COMPOSITE PLAN (FOR REFERENCE ONLY)

DRAWING TITLE
PROPOSED DEMOLITION PLAN

DRAWING TITLE
EXISTING SITE PLAN (FOR REFER. ONLY)

DRAWING TITLE
PROPOSED DIMENSIONED SITE PLAN

1 COMPOSITE PLAN
 SCALE: 1" = 10'-0" (FOR REFERENCE ONLY)

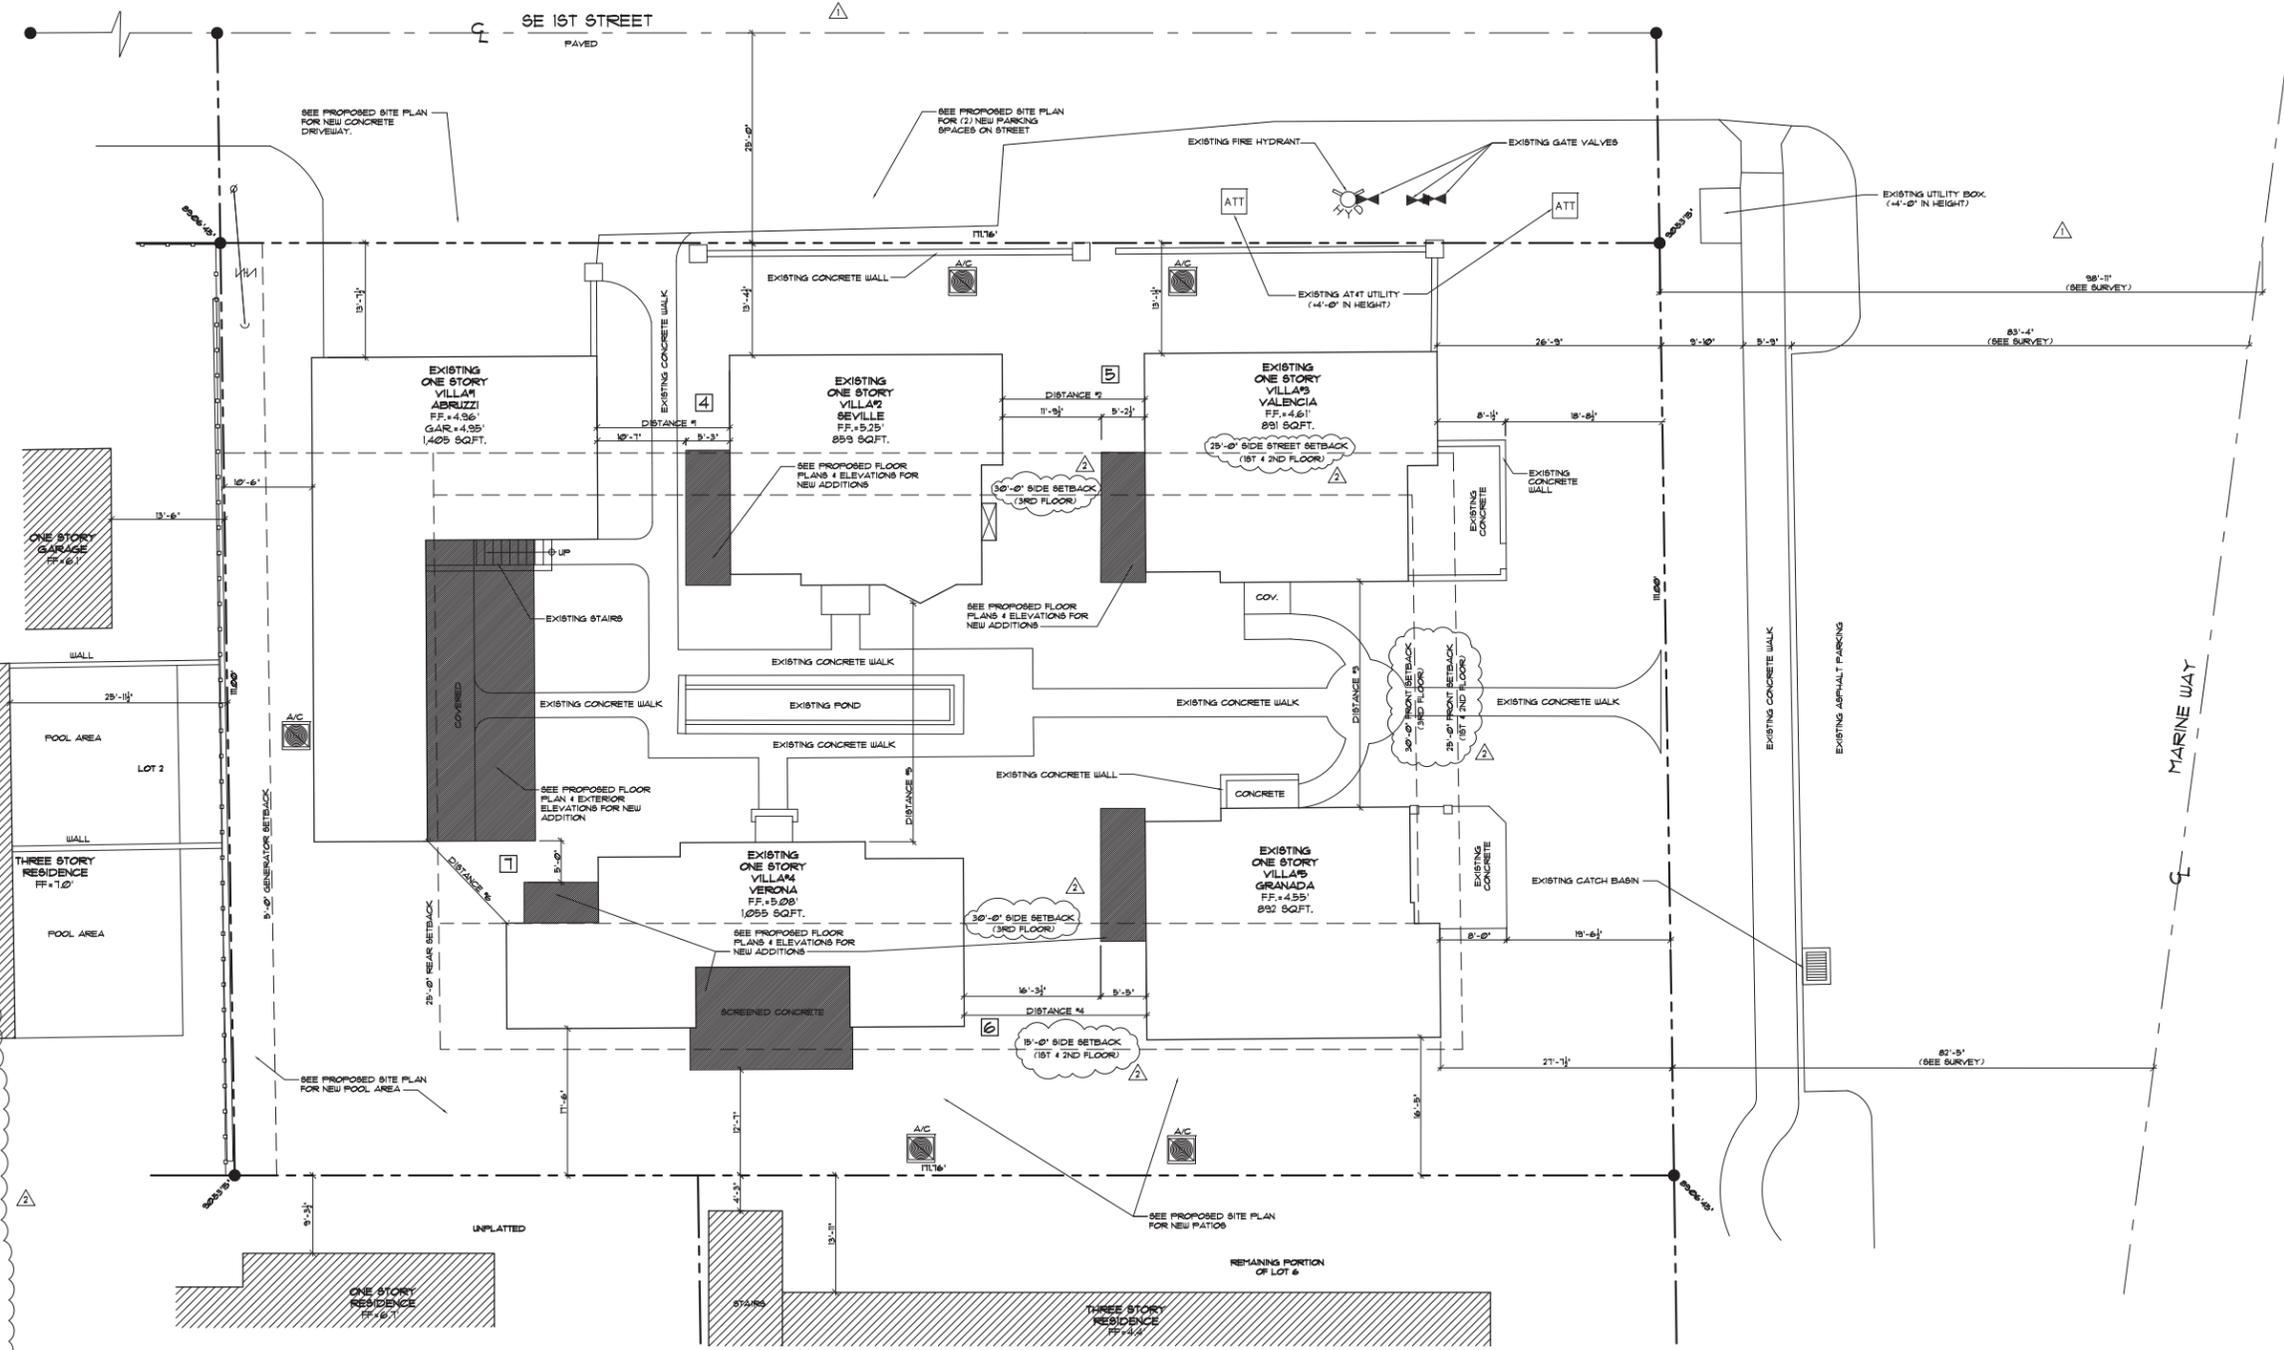
REVISIONS
 1. REVISED 6.30.19 AS PER CITY COMMENTS:
 1. ADDED DIMENSIONS TO CENTER LINE OF ADJACENT ROADS.
 2. REVISED 8.16.19 AS PER CITY COMMENTS:
 1. UPDATED SETBACKS.

PROPOSED DEMOLITION PLAN
SCALE: 1" = 10'-0"

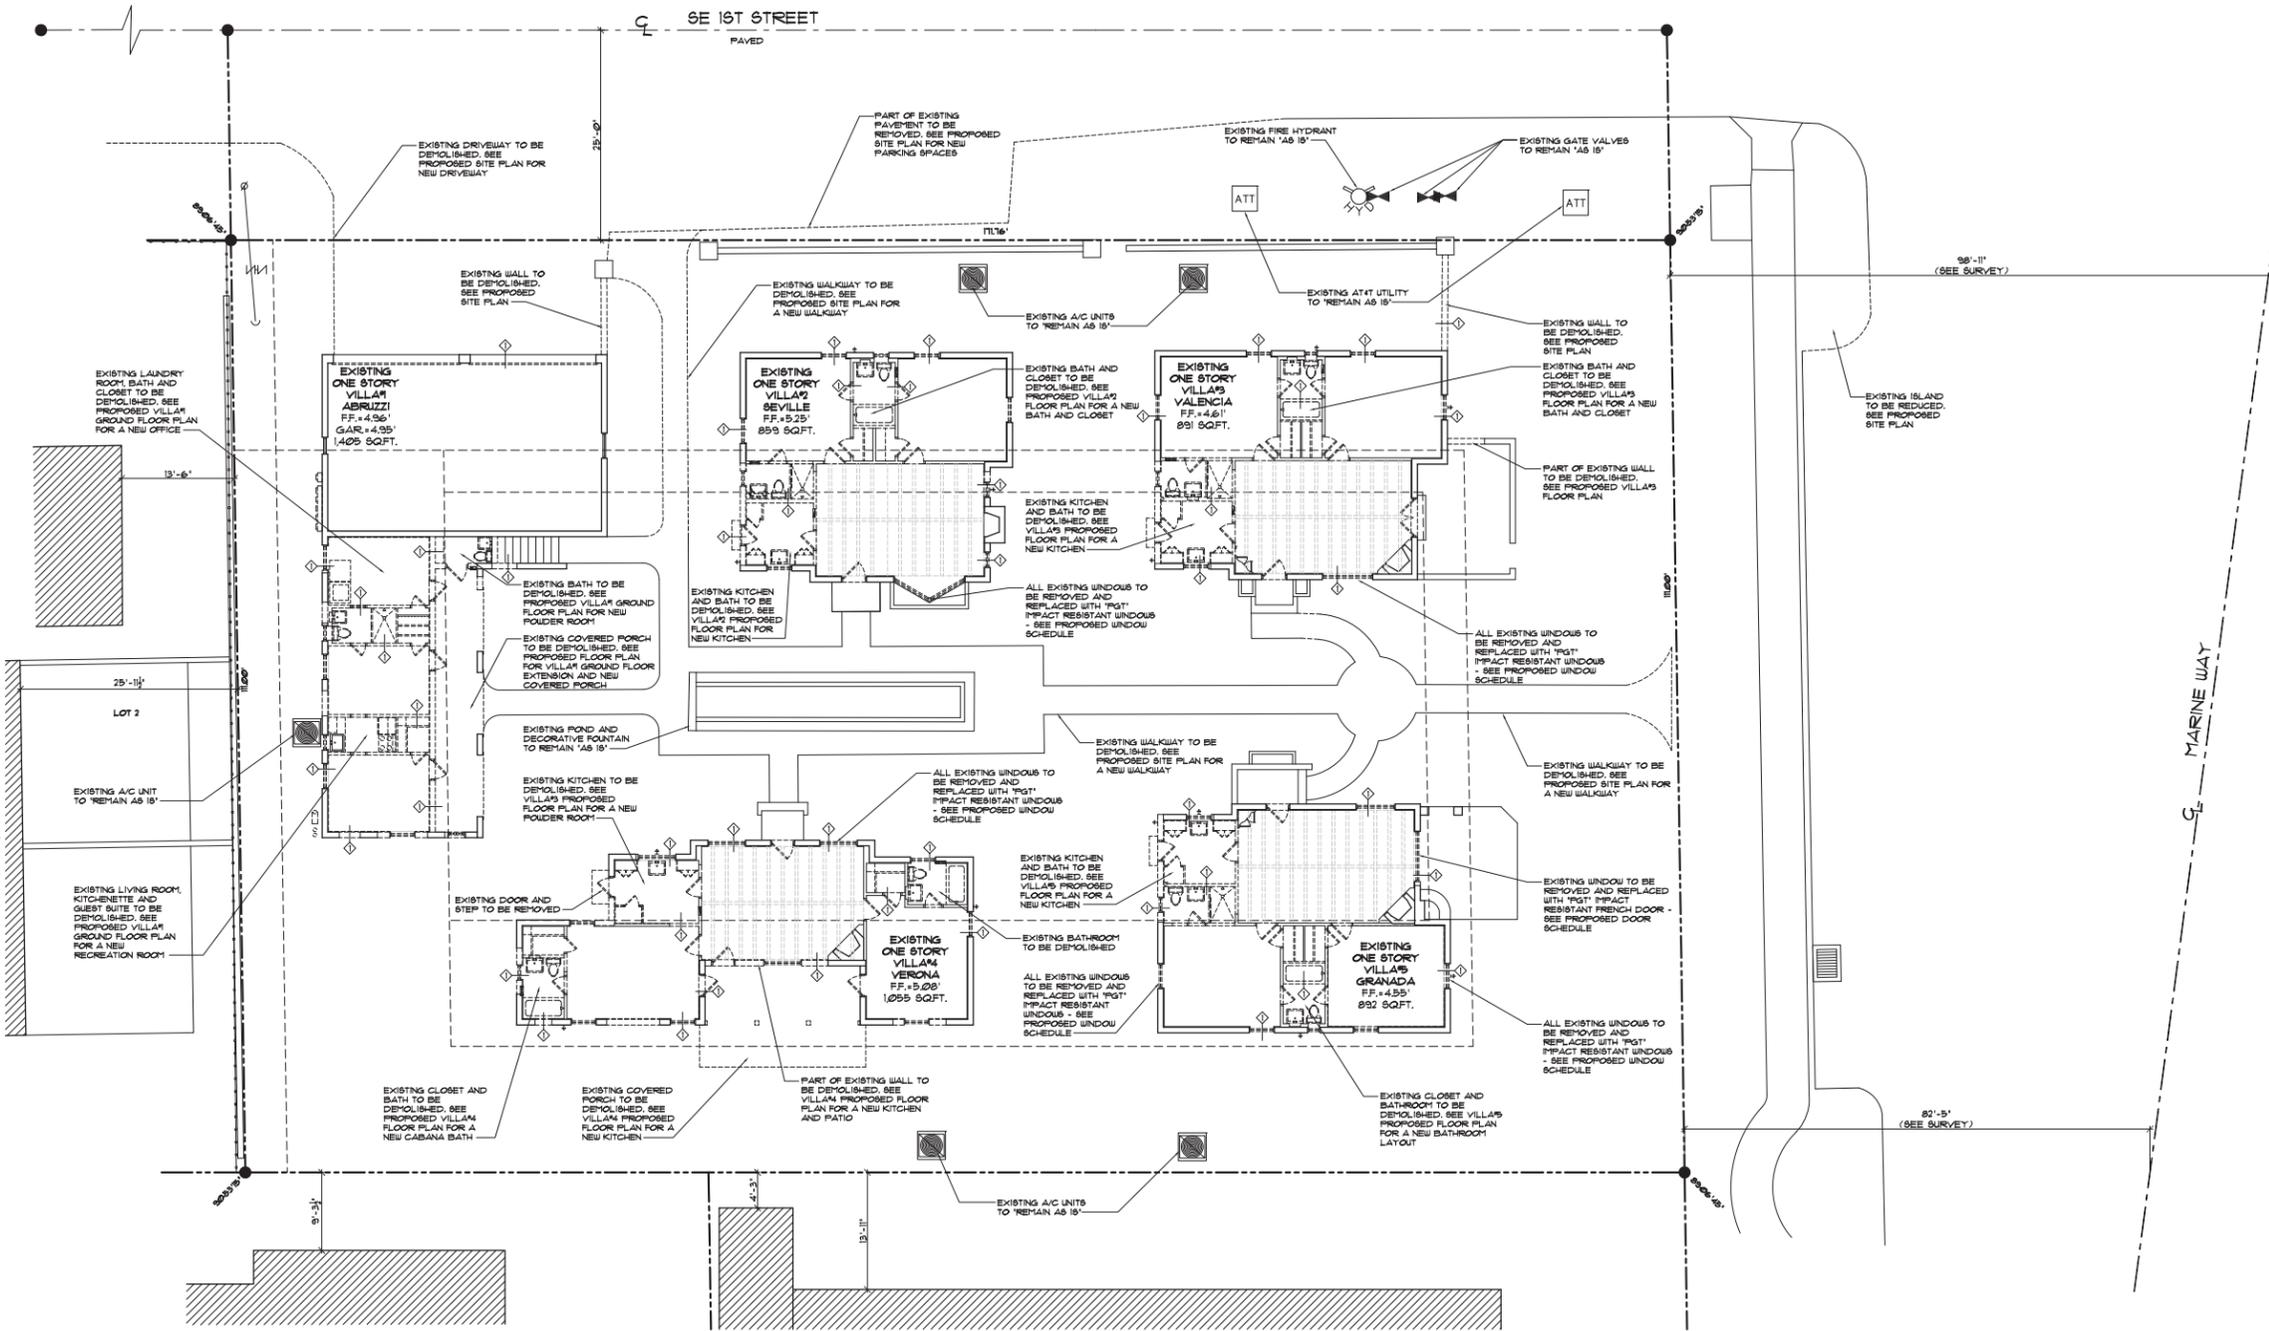
REVISIONS
1. REVISED 6/30/19 AS PER CITY COMMENTS
2. PROVIDED DEMOLITION FLOOR PLAN/SITE PLAN

1 EXISTING SITE PLAN
 SCALE: 1" = 10'-0"
 (FOR REFERENCE ONLY)

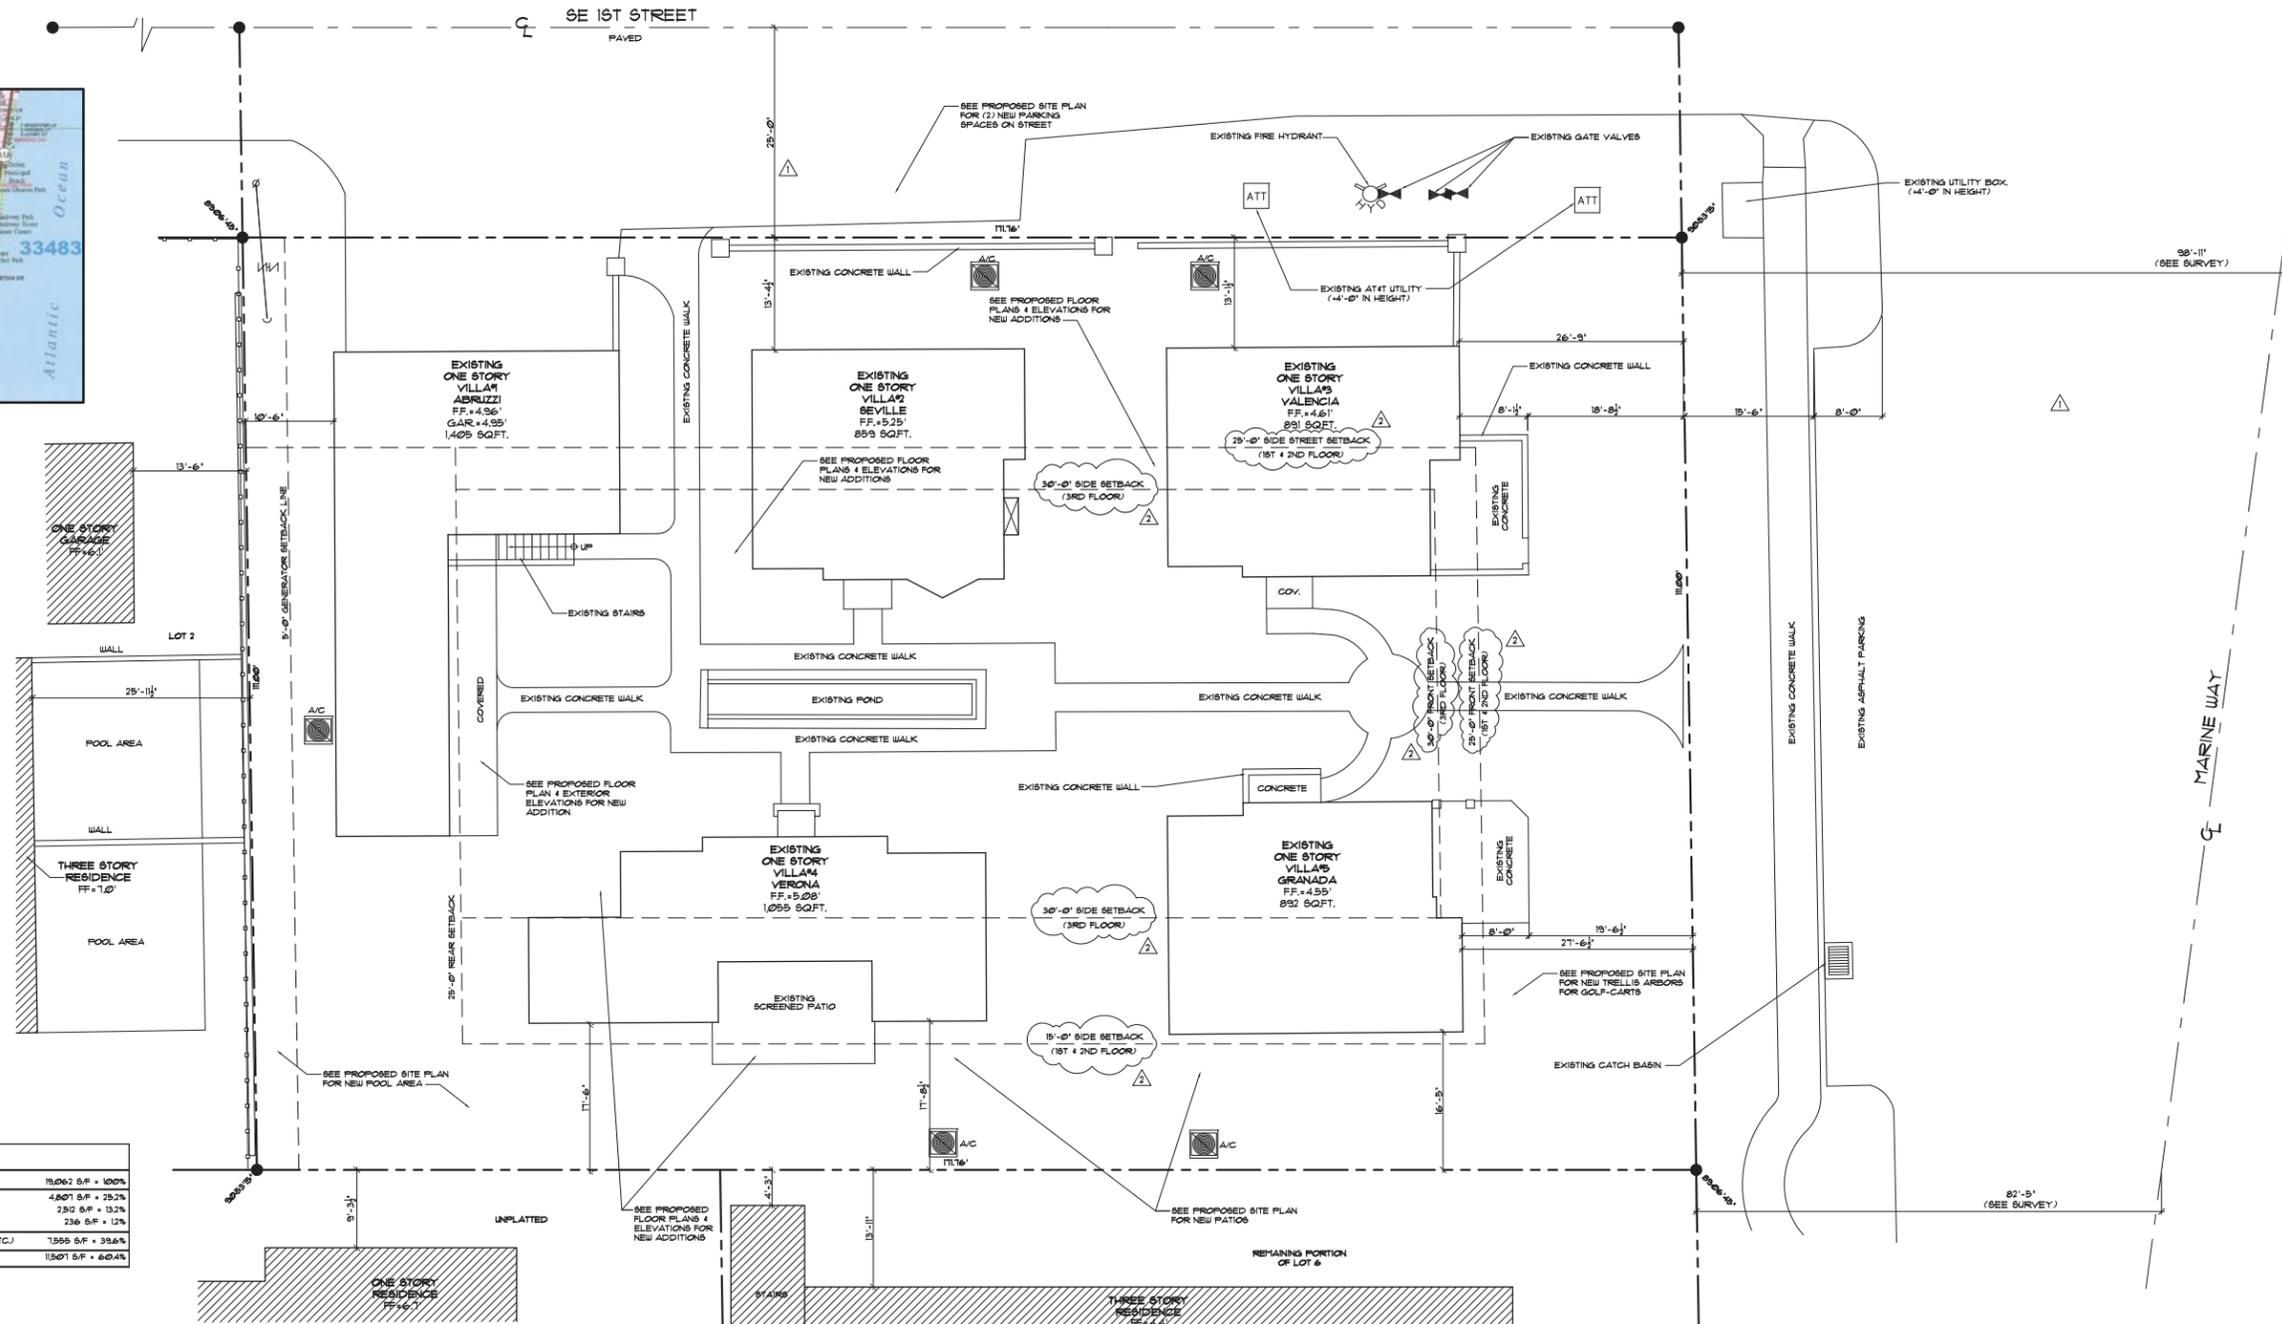
REVISIONS
 Δ REVISED 6.30.18 AS PER CITY COMMENTS
 Δ ADDED DIMENSIONS TO CENTER LINE OF ADJACENT ROAD.
 Δ REVISED 9.16.18 AS PER CITY COMMENTS.
 1. UPDATED SETBACKS.
